Comments submitted by Interested Persons

- **Roger Collins, Birch Point Campers Association**

RE: Richard Cayer NRPA Permit Application

ERROR IN ORIGINAL PROPOSAL - BANK HEIGHT
ESTIMATED TOO LOW

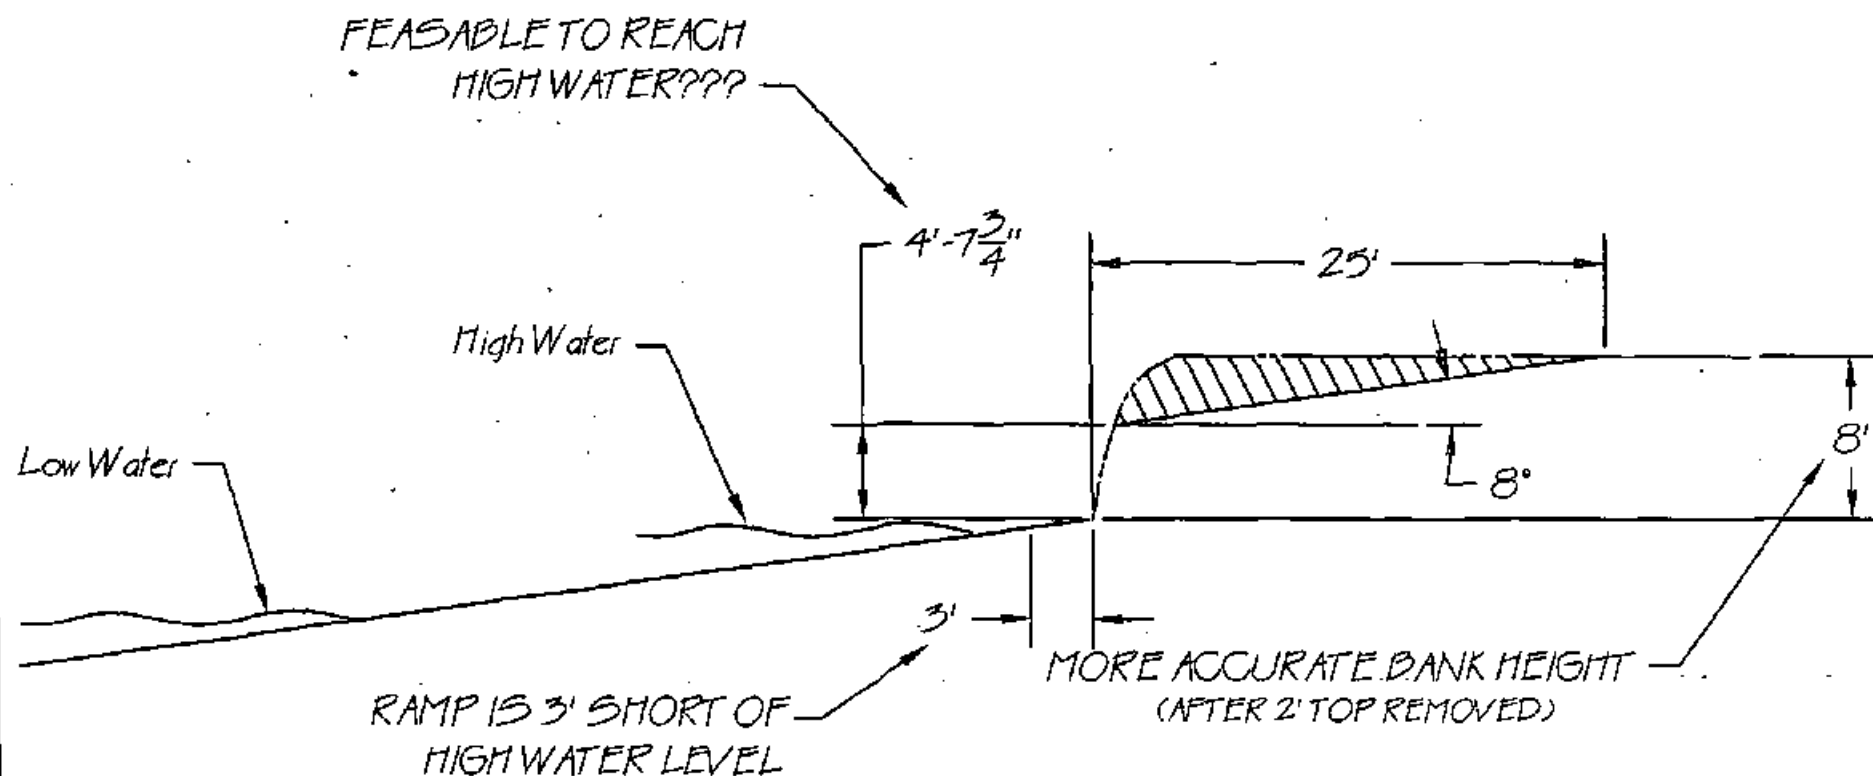
Attachments A, B, C, D are engineered drawings illustrating the design shortcoming of the applicant's submission and the resultant implications. There appears to be a misrepresentation concerning the amount of soil to be removed due to the application using inaccurate bank height data. The actual

25' LONG RAMP W/8% GRADE DOES NOT REACH HIGH WATER LEVEL

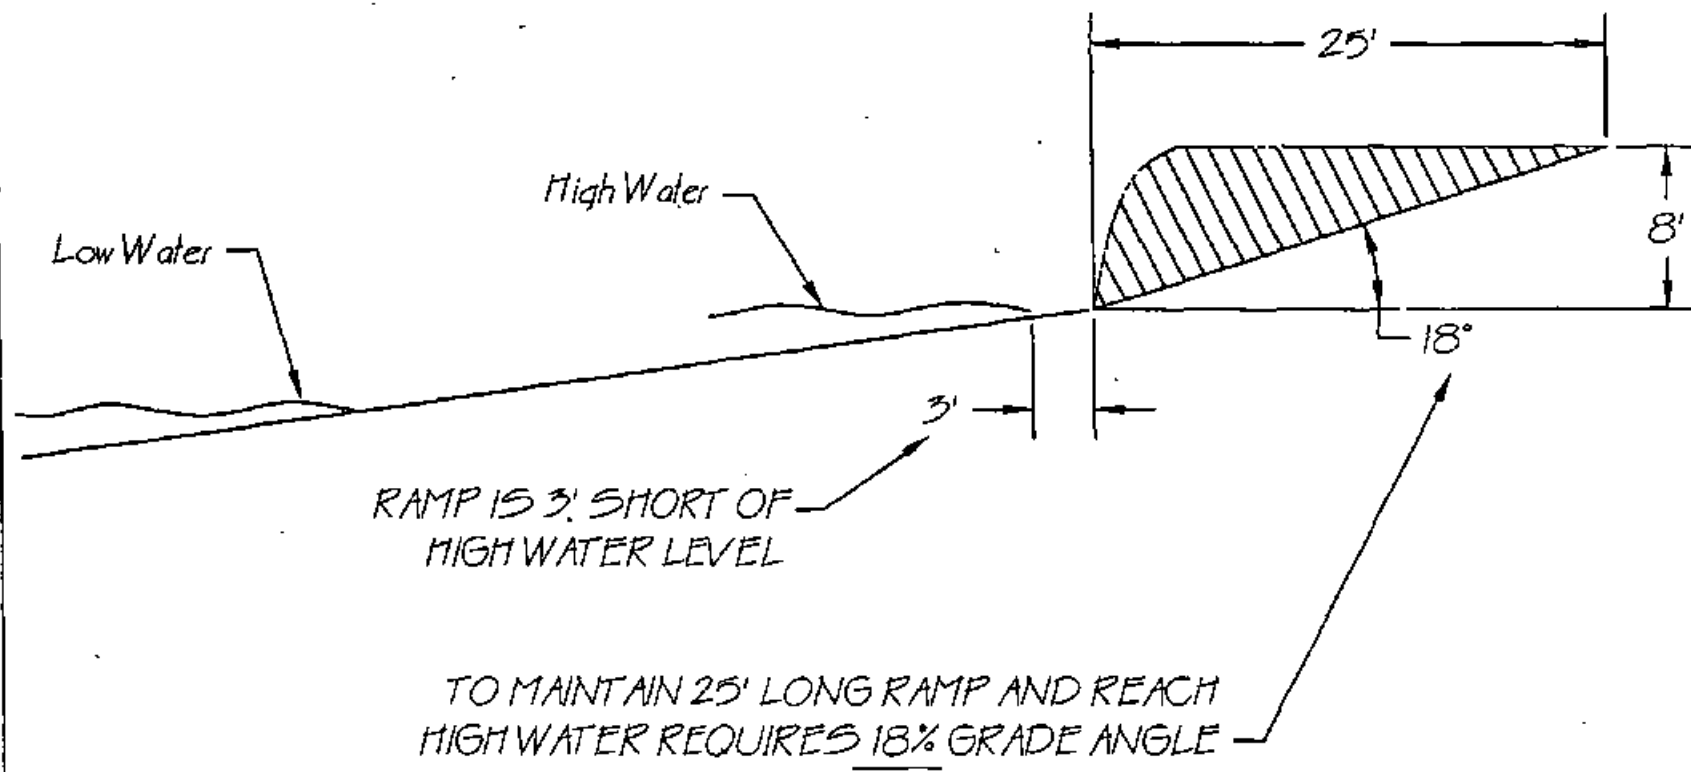
The applicant does not indicate how much regulated wetland would be impacted by launching boats of the size mentioned. A cross section should be provided to illustrate just how far a "rig" (boat trailer and towing vehicle) must traverse the wetland to float the boat. Instead; the subject is deceptively avoided by claiming that the ramp will stop 3 feet short of the high water mark.

REQUIRED TURNING RADIUS BASED
ON ENGINEERING STANDARDS

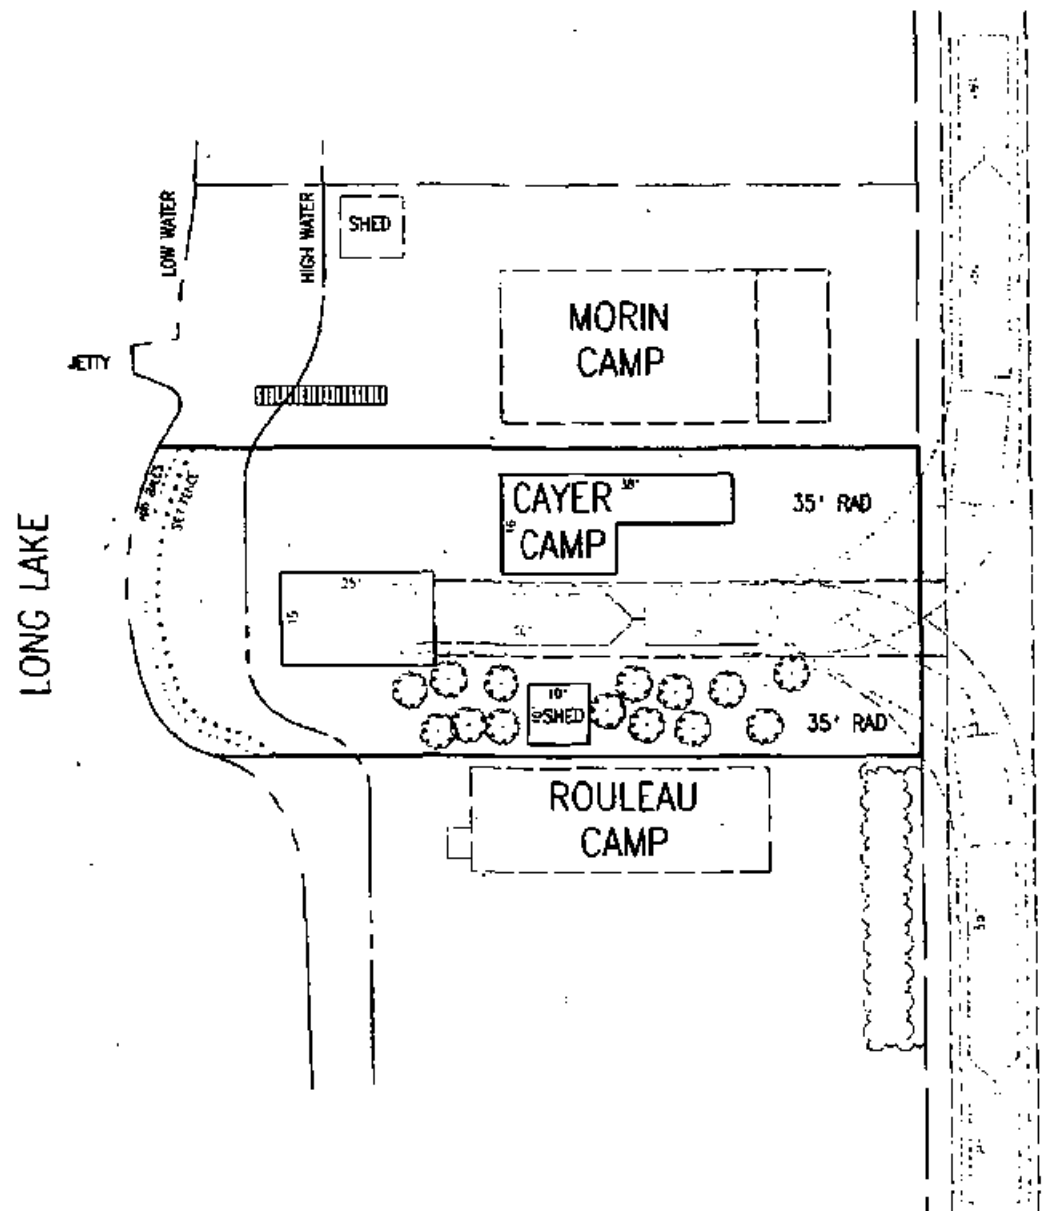
drive without considerable "jockeying" This inevitably will obstruct vehicular travel in the right-of-way and create a pedestrian safety hazard. Please refer to the attachment that depicts how severely constrained the turning radius will be in entering and exiting the launch site.

NOTE: TURNING RADIUS ON
APPLICATION NOT FUNCTIONAL
